Access Compliance Report Public Rights-of-Way (Curb Ramps)

Main Street: HEARTHSIDE_RD	Cross Street: BRYNWOOD_LN	Location:	SE
----------------------------	---------------------------	-----------	----

ADA ID: RPAT211104134152	Ramp Type: Type 4 - Parallel	Initial Pass/Fail: Fail	Overall Compliance: No	Severity Score:	16
--------------------------	------------------------------	-------------------------	------------------------	-----------------	----

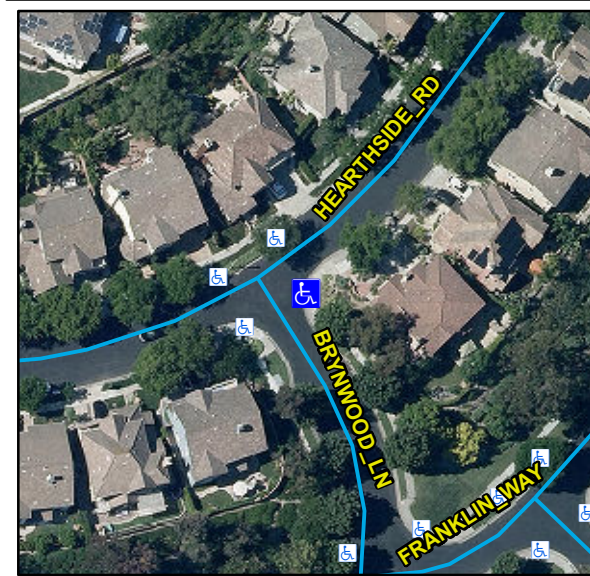
Compliance	Description	Data	Compliance	Description	Data
N/A	Ramp Length LT (in)	95	N/A	Ramp Length RT (in)	93
Yes	Ramp Width LT (in)	53	Yes	Ramp Width RT (in)	53
No	Ramp Run Slope LT (%)	9	Yes	Ramp Run Slope RT (%)	0.6
No	Ramp Cross Slope LT (%)	2.5	Yes	Ramp Cross Slope RT (%)	2
N/A	Landing Present	N/A	N/A	DWS Provided	N/A
N/A	Landing Length (in)	N/A	N/A	DWS Contrast	N/A
N/A	Landing Width (in)	N/A	N/A	DWS Length (in)	N/A
N/A	Landing Run Slope (%)	N/A	N/A	DWS Full Width	N/A
N/A	Landing Cross Slope (%)	N/A		DWS Offset Type	N/A
N/A	Landing Movement Obstructed?	N/A	N/A	DWS Offset Left (in)	N/A
	Landing Movement Type	N/A	N/A	DWS Offset Right (in)	N/A
N/A	Landing Shared	N/A			
N/A	Clear Space	Yes			
N/A	Clear Space To Crosswalk (in)	N/A			
N/A	Marked Crosswalk 1	No	N/A	Marked Crosswalk 2	No
	Crossing 1 Direction	N		Crossing 2 Direction	W
	Marked Crosswalk 1 Width (in)	N/A		Marked Crosswalk 2 Width (in)	N/A
N/A	Ramp Inside Crosswalk 1	N/A	N/A	Ramp Inside Crosswalk 2	N/A

Possible Solutions:
Remove & Replace Curb Ramp With Two New Directional Ramps or Equivalent.
